ADDENDUM NUMBER: Two (2)

TITLE: Replace Continuous Ship Unloader (CSU) Spiral Chute at Northside Generating Station (NGS)

JEA SOLICITATION NUMBER: 1412175449

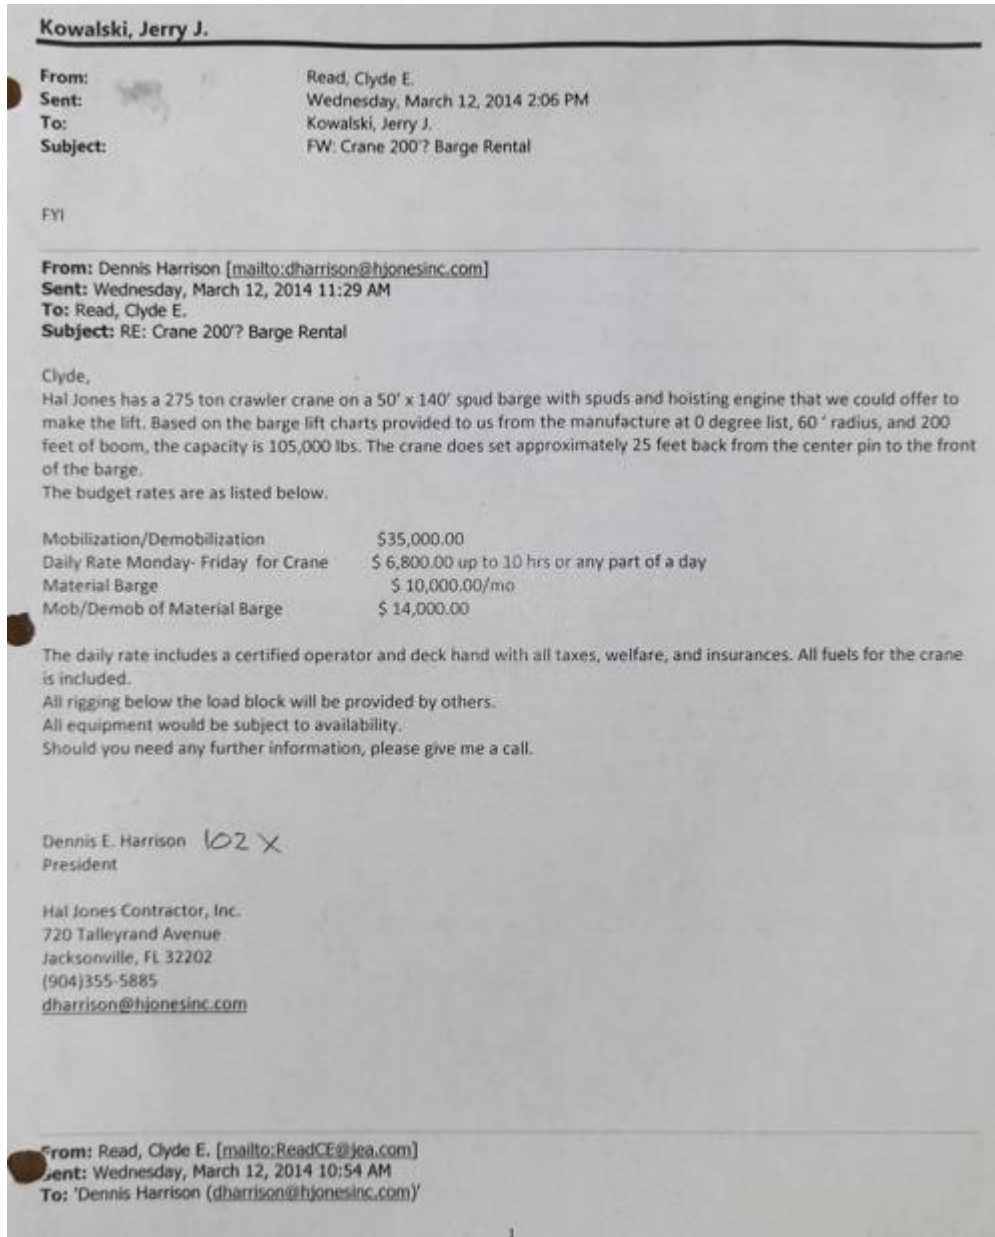
1. The expectation of JEA in bidding the fabrication and installation in one Solicitation is that the awardees will work as a unified team. The lead company (fabricator or contractor) will coordinate with JEA and ensure the fabrication process supports a safe and successful installation.
2. In section 2.5 the original technical specifications stated:

Liner plates are to be fabricated from the same through hardened, wear resistant, steel as the segment plates or at a minimum AR400.

JEA is amending this technical specification to:

Liner plates are to be fabricated from the same through hardened, wear resistant, steel as the segment plates or at a minimum AR400F (formable).
